Supply Chain Slide: Critique and Redesign

Iwatani Corporation — Metals Department → Stainless Steel Division

Bellows tube (precision-slit material) market entry,
leveraging the Jindal Stainless relationship

15 — Redesigning the Supply Chain Map Slide

The redesign

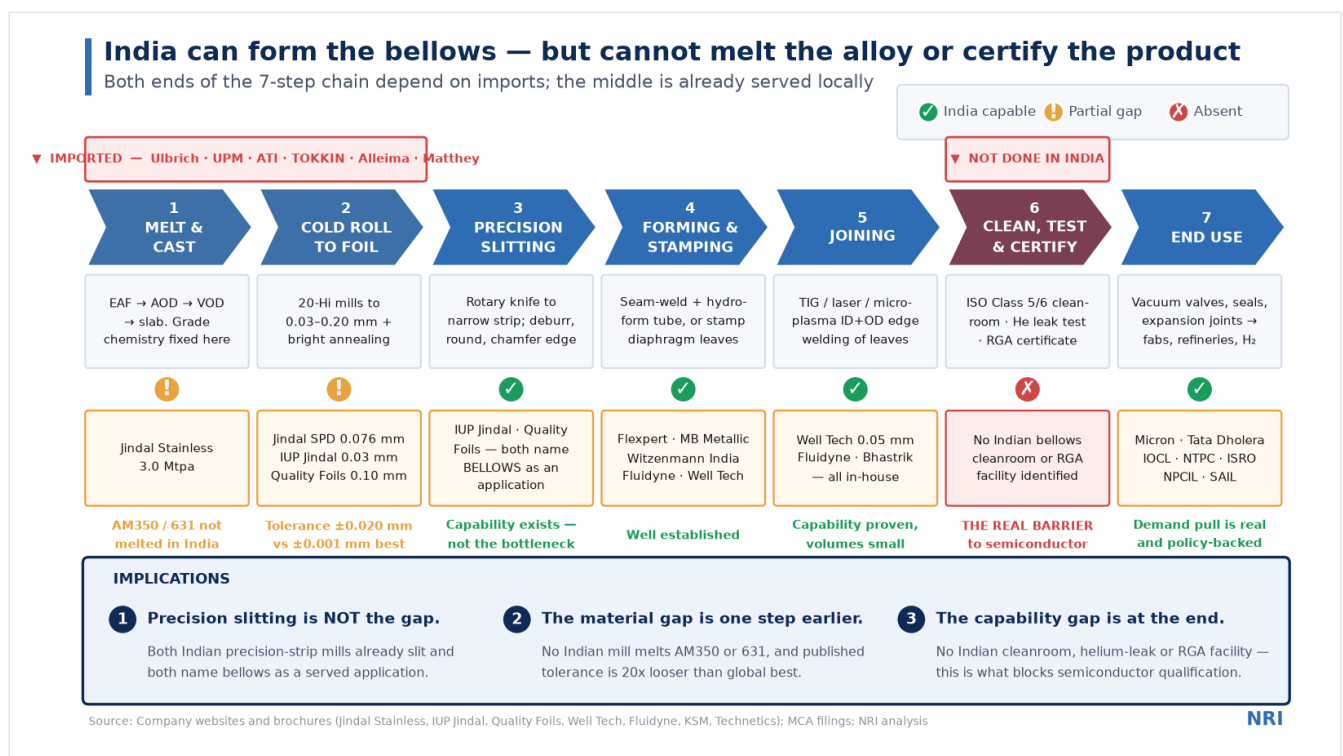
Fix these two facts before anything else

1. "Virami Alloys" (presumably Viraj) does not slit coil — or make flat products at all. Viraj Profiles is a **long products** manufacturer: wire rods, wires, welding wires, fasteners, bright bars, profiles, flanges. Its own site describes the business as exactly that, and its Section Rolling Mill in Tarapur makes angles, flats and profiles — structural sections, not cold-rolled coil. There is no flat-rolling or slitting operation ([viraj.com, profiles division](https://viraj.com/profiles-division)) [P]. Naming Viraj as a coil slitter is a factual error on the one topic the client knows best.

2. "Jainex Steel" is a two-person trading company, not a slitting service provider. Jainex Steel & Metal, Mumbai, is registered as "**Trader - Wholesaler/Distributor**" and describes itself as an "importer, stockiest & supplier" of stainless and nickel alloy sheet, strip, foil, coil and shims. Its address is a shop in Khetwadi Lane, Girgaon — a trading office. LinkedIn lists **2 employees** (stainlesssteelcoils.in, [LinkedIn](https://www.linkedin.com/company/jainex-steel)) [U].

And the framing needs a small but important correction. The slide says Indian bellows makers either outsource slitting to third parties or import pre-slit material. Both happen — but the sharper truth is that **imports are driven by grade, not by slitting**. Austenitic 304/316/321 at 0.10 mm and up is bought locally. AM350, 631, Inconel, Hastelloy and sub-0.05 mm foil are imported because **no Indian mill melts or rolls them at all**.

What is structurally wrong with the slide

#	Issue	Why it matters
1	"Bellow manufacturer" is a chevron.	It is an actor, not a process step. The sequence reads Forming → Joining → Finishing → ...Manufacturer, which breaks the logic.
2	The chain stops at the factory gate.	No customers, no applications, no demand. For a market-entry deck the "so what" is missing entirely — the client cannot see where money is made.
3	No action title.	"Manufacturing process & supply chain map" labels the slide instead of stating its conclusion. The consulting standard is a title that carries the message.
4	The key insight is buried in body copy.	The most valuable line on the slide — no Indian bellows maker slits in-house — sits in small underlined text inside a box. It should be the headline.
5	Underlined text and em-dash prose inside boxes.	Underlining reads as a hyperlink or a typo. The box reads as a paragraph, not slide copy.
6	Orphan legend.	"Imports supplementing domestic supply" with a diamond marker, but no diamonds appear anywhere on the slide.

7	Inconsistent grid.	Two chevrons in row 1, four in row 2. Some columns have two boxes, one has a single box. There is no consistent row meaning, so the eye has nothing to scan along.
8	Nothing is visually prioritised.	Every box is the same blue and white. With no colour encoding, the audience does not know where to look and the insight does not land.
9	Upstream/downstream split is arbitrary.	Slitting is "upstream" and forming "downstream", but both are manufacturing. The meaningful distinction is material → component → application.

Use these names instead

Role	Correct Indian names
Precision strip mills that slit AND serve bellows	IUP Jindal Metals & Alloys (Ghaziabad; 0.03–1.5 mm; 22,000 tpa; three Brodeur slitting lines with shimless tooling; edge-rounding machine; application list includes "Flexi metal tubes / bellows") · Quality Foils (India) (Hisar; 0.10–4.00 mm; slit edge from 5.0 mm; product listing includes "Metallic Bellows" and "Bellows for precision measuring instruments")
Other Hisar-cluster strip mills	Jindal Stainless SPD (84,000 tpa, to 0.076 mm, precision slitters) · Hisar Metal Industries · Singhal Strips
Importers and stockists	Aesteiron (lists AM350/S35000 strip) · Sachiya Steel · Jainex Steel & Metal · Riddhi Siddhi Impex
Not relevant to flat/slitting	~~Viraj~~ (long products) · ~~Mukand~~ (bars, wire rod)

What changed and why

Change	Reason
Action title states the conclusion — "India can form the bellows — but cannot melt the alloy or certify the product"	The audience gets the message in three seconds. Everything below is now evidence rather than information.
One continuous 7-step row, no upstream/downstream split	A single left-to-right read. Seven is at the upper limit of what a slide can hold, but it keeps the chain intact from melt to end use.
Chain extended to END USE	Answers "who pays". Names Micron, Tata Dholera, IOCL, NTPC, ISRO, NPCIL, SAIL — which also makes the slide relevant to the demand case.
Strict three-row matrix under every chevron — process, India players, so-what	The eye can scan horizontally along any row. Consistency is what makes a dense slide feel simple.
Traffic-light status per step (✓ capable / ! partial / X absent)	This is the single biggest improvement. The audience sees two amber and one red before reading a word. The insight is now carried by colour, not text.

Import dependency shown as a red band above the affected steps only	Makes the orphan legend meaningful and puts the import story where it belongs — attached to specific steps, naming the actual suppliers.
"Bellow manufacturer" removed as a step	Replaced with the real remaining stages: clean/test/certify, then end use.
Bottom "Implications" band with three numbered points	Consulting convention: the reader should be able to take away the slide's argument without studying the matrix.
Highlighted the one step that is the real barrier	Step 6 is coloured differently in the chevron itself, so the eye lands there.

Simpler alternative for an executive audience

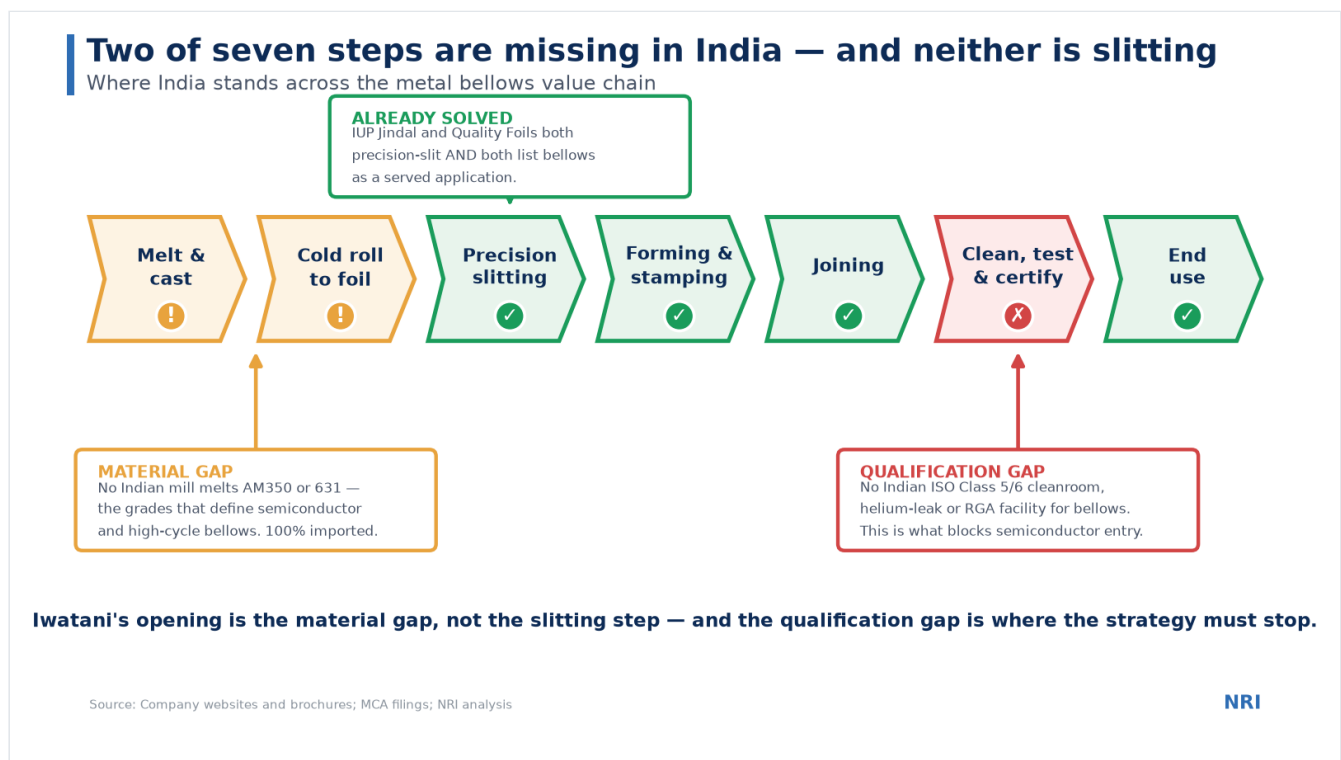
If the slide is for a steering committee or the first five minutes of a readout, strip it back to one bar and three callouts:

Same message, roughly one-fifth of the ink. The rule of thumb: **the detailed version is a working document for the project team, the simple version is for the decision-maker.** Most decks need both, on consecutive slides — the exec version first, the detail as backup.
